THERMOCHEM FURNACES PVT.LTD.

As per your requirement I have sent an offer of Aluminum billet Heating Furnace with hot log shear.

BP1 PRESS(±0.0 LVL)+Tunnel Furnace & Hot Log Shear(@ -1700LVL.)
 NAME DATE
 DRN ARUL 17-12-22
 CKD
 APPD
 DRAWING NO
 PR-Dec22-01

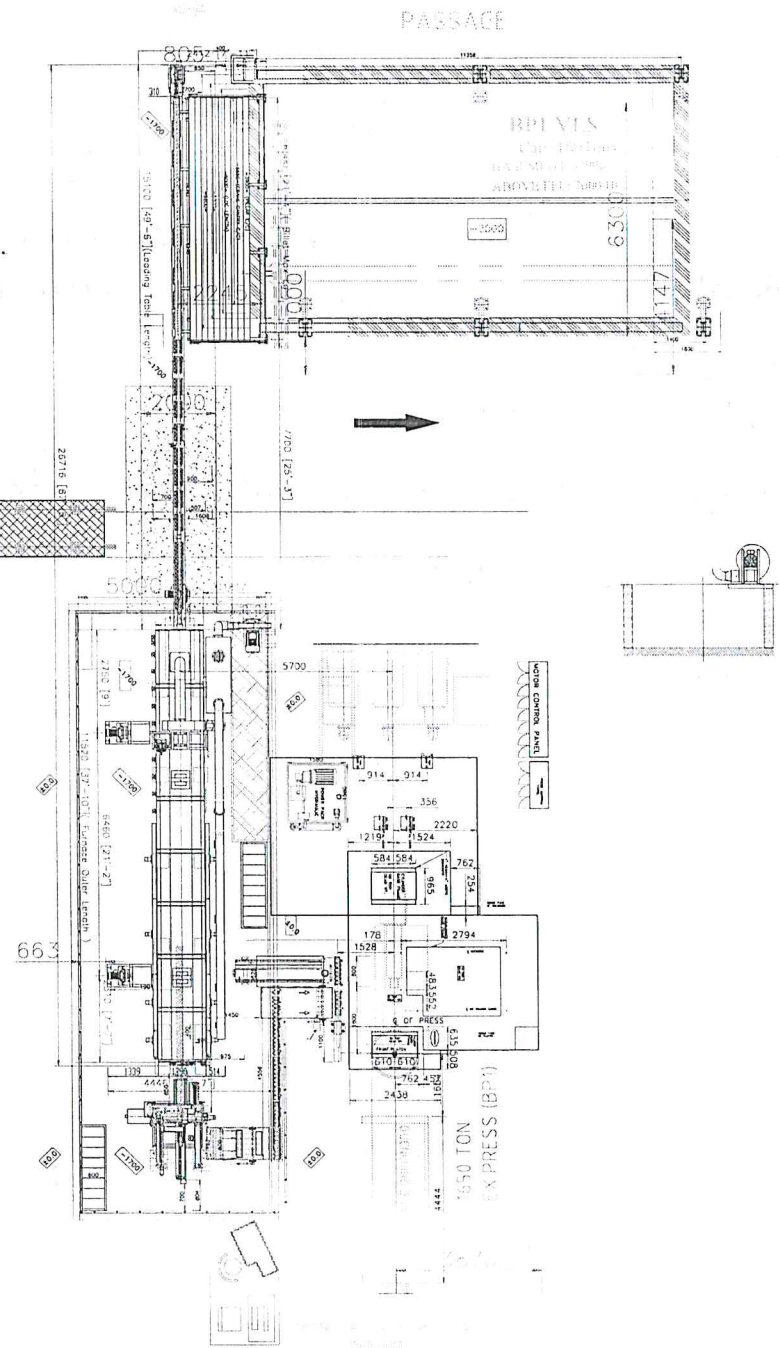
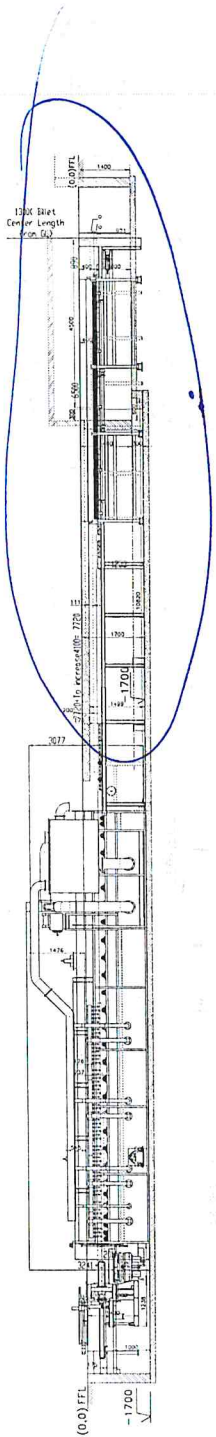
Thanks for sharing the G.A drawings; we have checked the same with our layout and found some below mentioned points that need to be confirmed from your end.

- 1) Log Feeding Conveyor to be extended by 4100mm to meet the Log feeding Location.
- 2) Combustion Blower to be kept at all the Factory Floor level (0,0) as shown in the Modified drawing and the Tunnel Furnace & Hot Log Shear Base Positioned at -1700 LVL.

Kindly Check the attached modification drawing and do the necessary changes accordingly.
